CITY OF ALBUQUERQUE

**Re: Bernalillo County Paradise Hills Community Center, 5901 Paradise
Boulevard, Grading And Drainage Plan Engineer's Stamp Date 12-07-11
(B10/D011)**

GRADING & DRAINAGE PLAN AND DETAILS

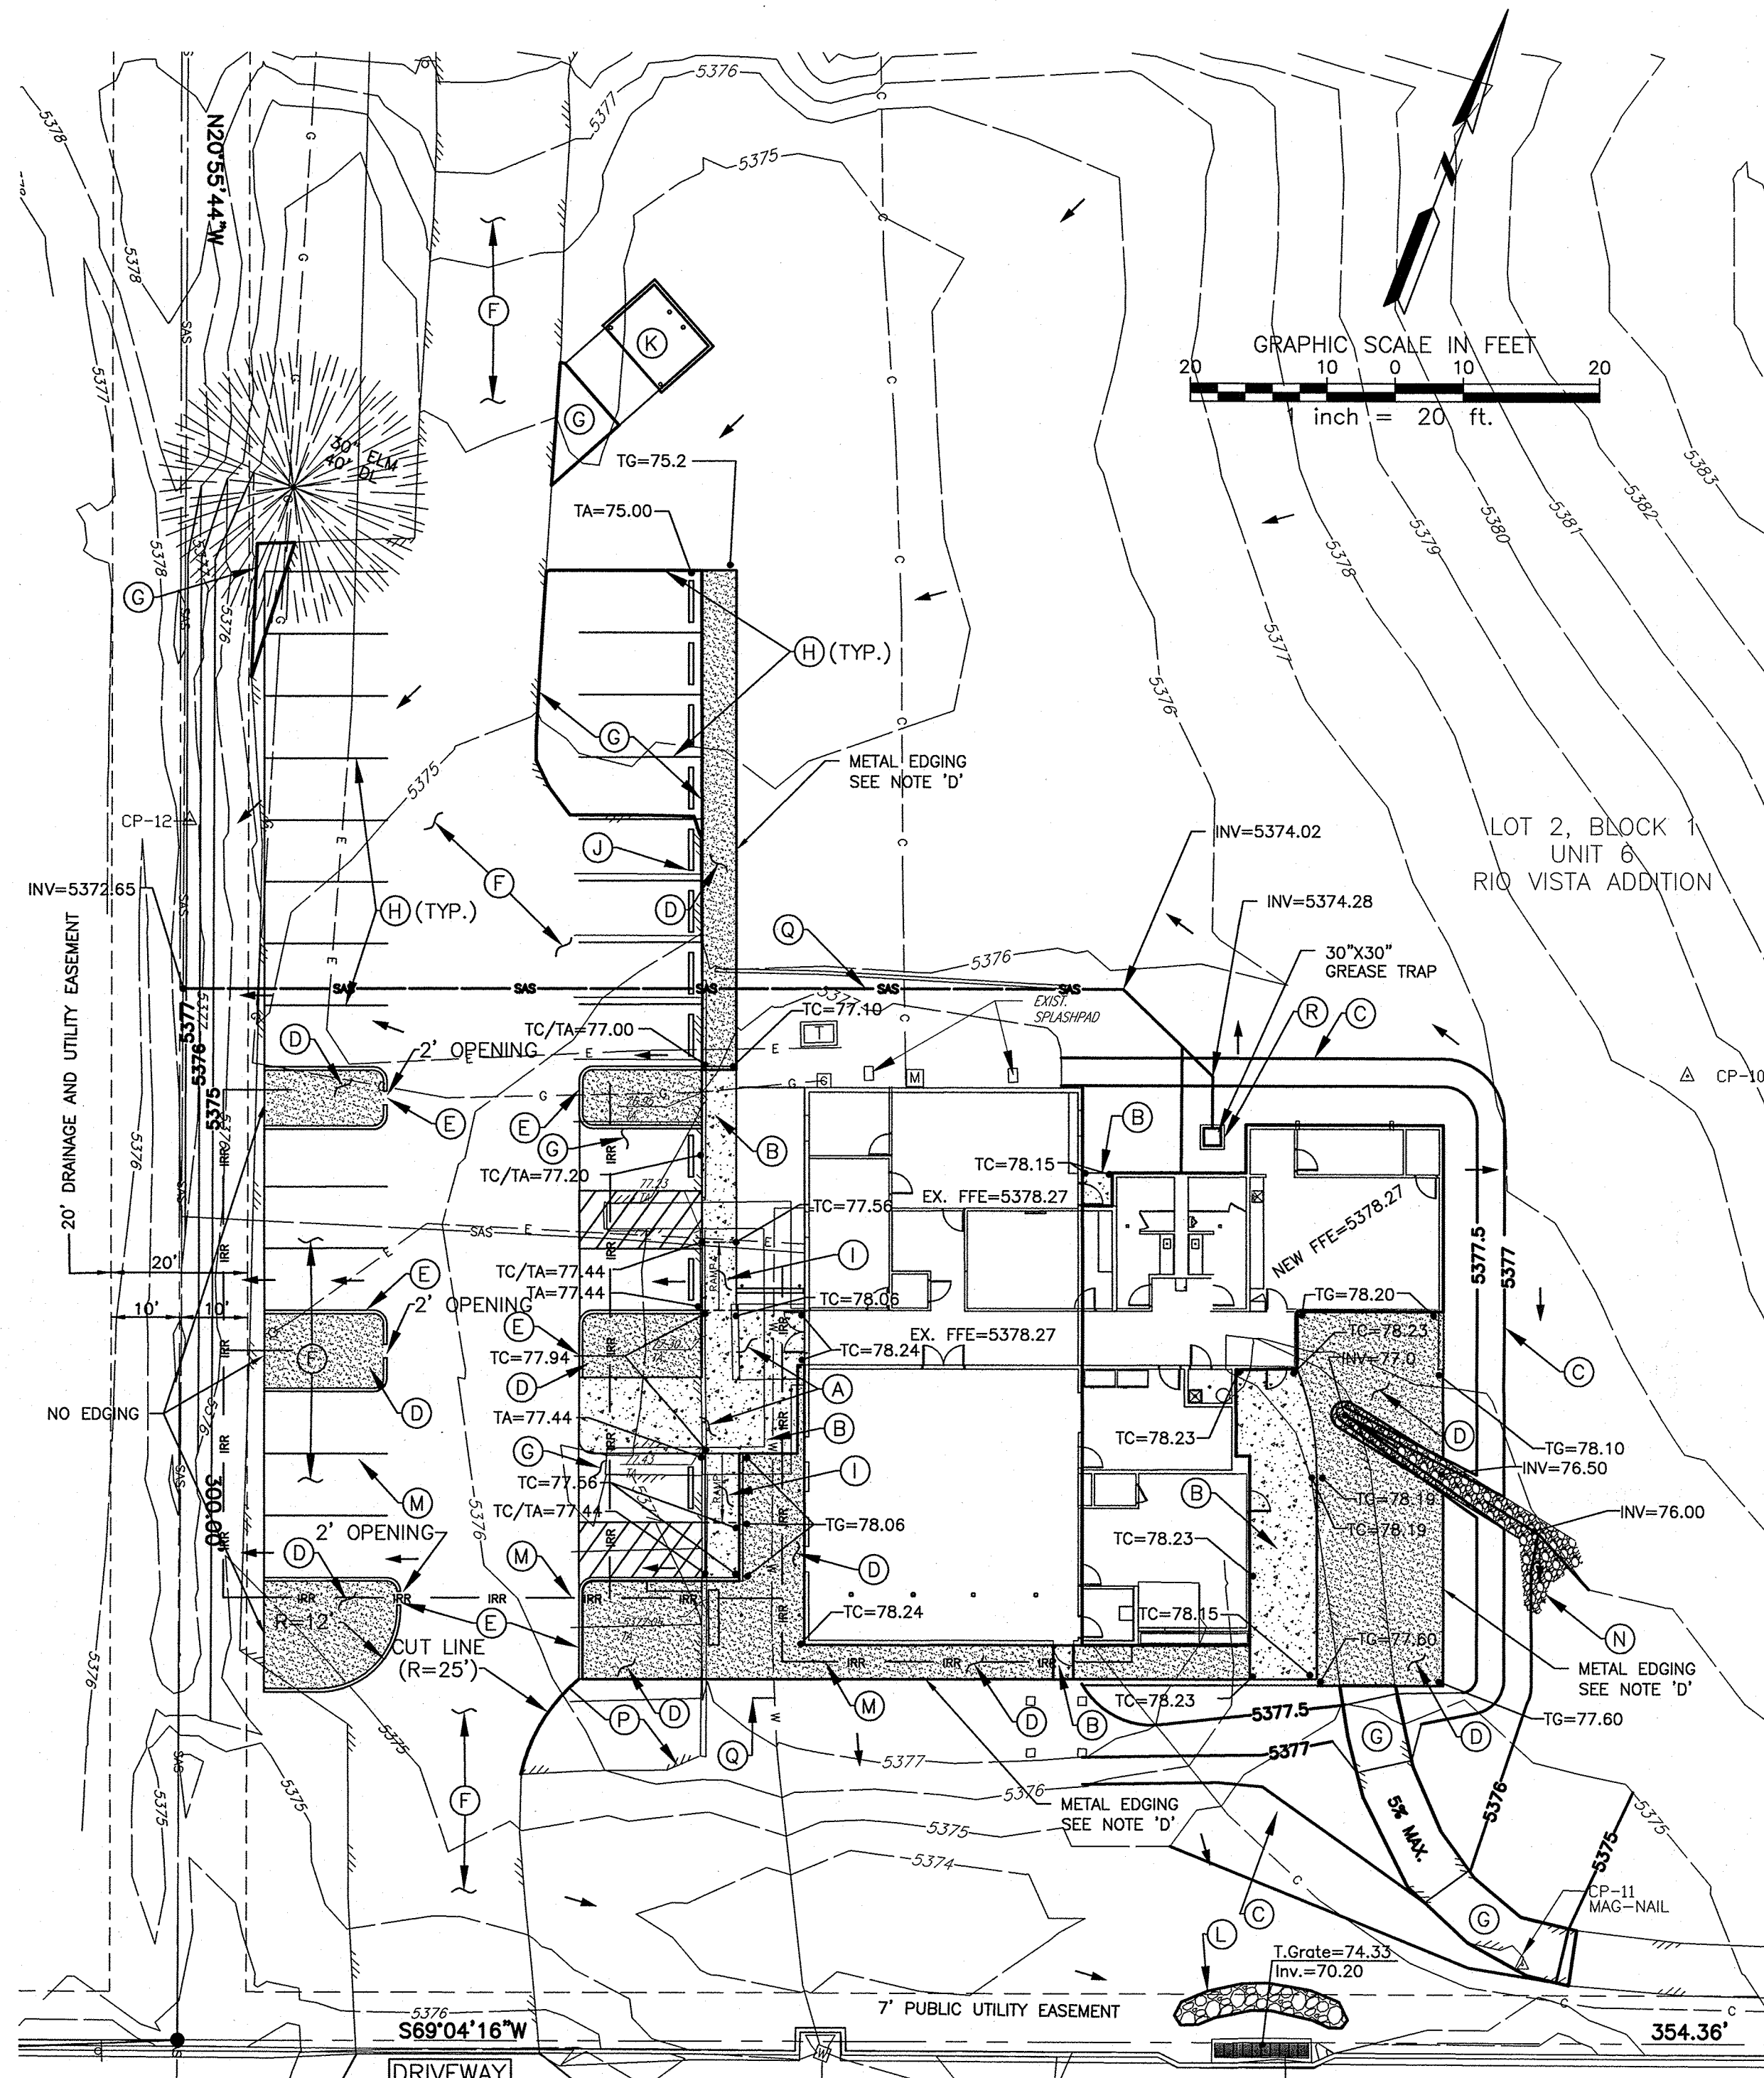
Based upon the information provided in your submittal received 12-14-11, the
grading and Drainage Plan is approved for the proposed discharge into the exiting storm
drain inlet located on the south side of the project.
